KiDO BD Co., Limited.

Plot-117, 125 & 126, Adamjee EPZ, Siddhirganj, Narayanganj

Issue 01

Main Building	
Observation-1: Stress in the column & foundation above normal design limit (Main Building).

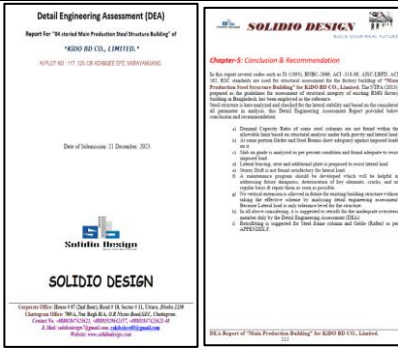
Description: Columns are stressed above normal design limits considering both gravity and lateral loading. Also, the cursory calculation indicates that footings are stressed above the normal design limit at the marked locations considering floor live load of 3 kPa for the typical floors, and 1.5 kPa for the roof. The building engineer is required to review design loads and column & foundation stresses. Also, produce and actively manage load management plans.

Observation 2: Lack of information in the design report (Main Building).

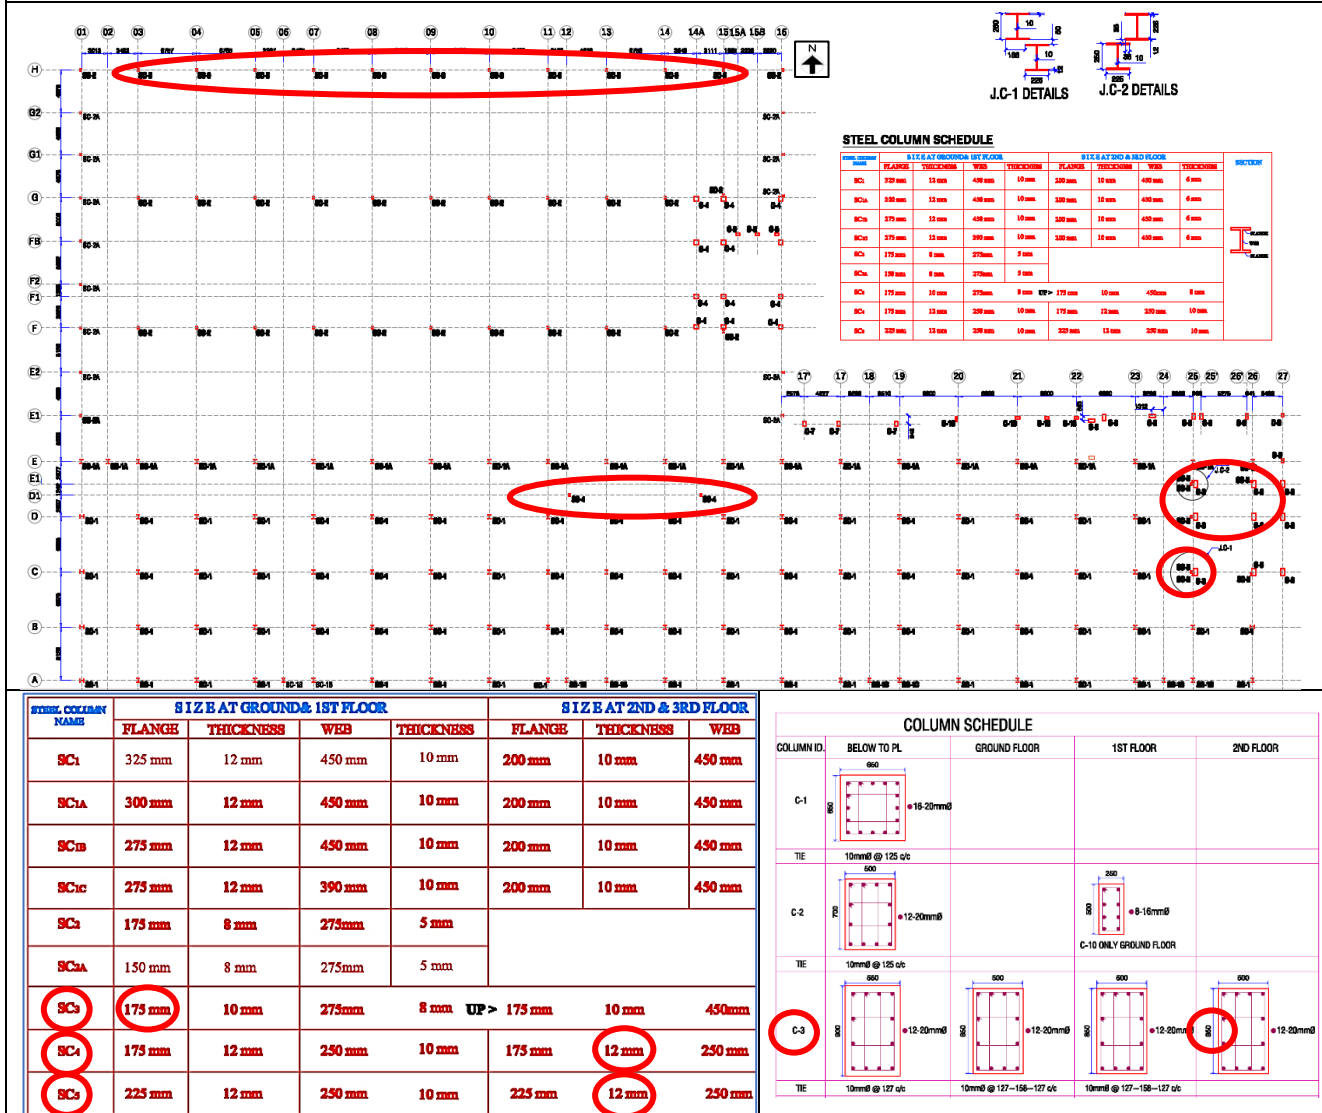
Lack of information	Steel Connections	Additional Load
Description: In the provided design report, the RC frame analysis and demand capacity ratio, foundation adequacy checks were not incorporated. Also, steel member connection adequacy further analysis and overstressed member recommendations were not provided in the design report. Loading from water tanks and screeding are not considered in the design report. The building engineer is required to update the design report in compliance with BNBC.

Column Layout & Schedule (mismatch in red marked area columns)

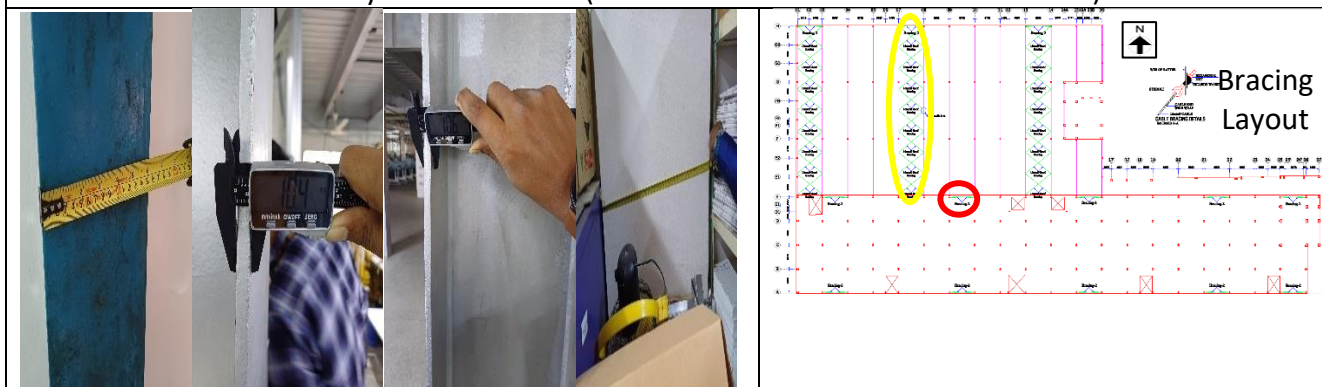
Description: As per the provided drawing, steel column SC3, SC4, SC5 sizes are W275~450 X F175(10), W250 X F175(12), W250 X F225(12) respectively and RC column C3 size is 500X850. During the inspection, RC column C3 size was observed as 500X700. As well as steel column SC3 flange width (150mm), SC4 & SC5 flange thickness (10mm) mismatches were observed apart from the provided drawing. Also bracing layout mismatch and missing were observed (yellow marked bracing location mismatch and red marked bracing missing).

A building engineer is required to survey the whole structure and prepare the as-built drawing reflecting the on-site condition as well as update the design report.

Observation-4: Lack of lateral load transfer media for the shed roof (Main Building).

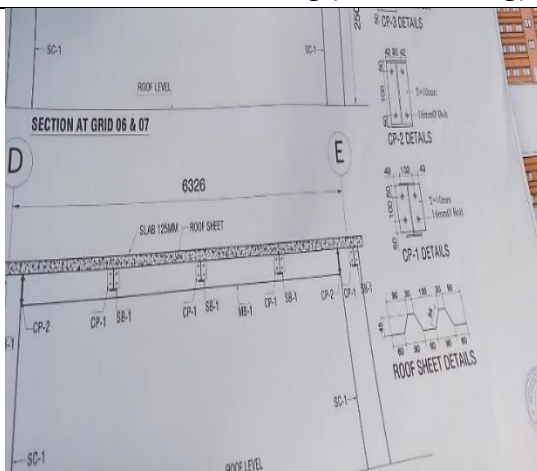
Description: The shed has portal framing action in the North-South direction. However, the roof shed does not have a lateral load transfer and load-resisting system along the East-West direction. Building engineer is required to check the lateral stability of the structure and suggest proper remedial actions.

Column Layout & Schedule (mismatch in red marked area columns)

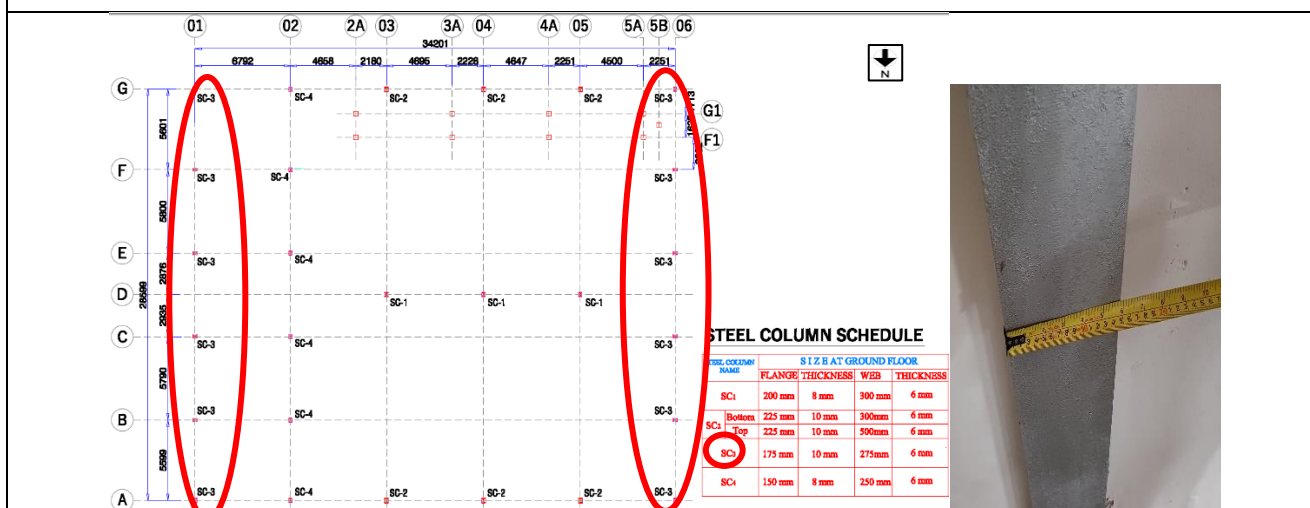
Description: As per the provided drawing, the steel column SC3 size is W275 X F175(10). During the inspection, SC3 size was observed as W275 X F150(10), flange width mismatch was observed apart from the provided drawing. A building engineer is required to survey the whole structure and prepare the as-built drawing reflecting the on-site condition as well as update the design report.

Observation-13: Mismatch & lack of information between the provided drawing and on-site condition.

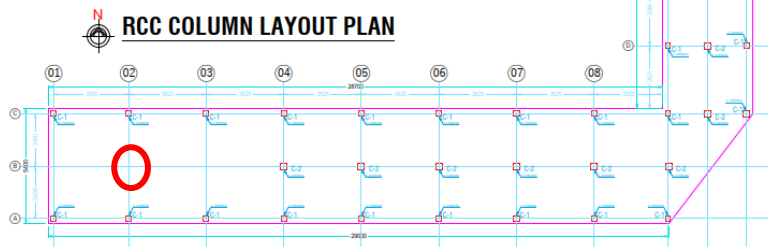
Description: During the inspection, additional columns and beams were observed apart from the drawing. Also, the foundation and retaining wall details were not incorporated in the provided drawing. A building engineer is required to survey the whole structure and prepare the as-built drawing reflecting the on-site condition.
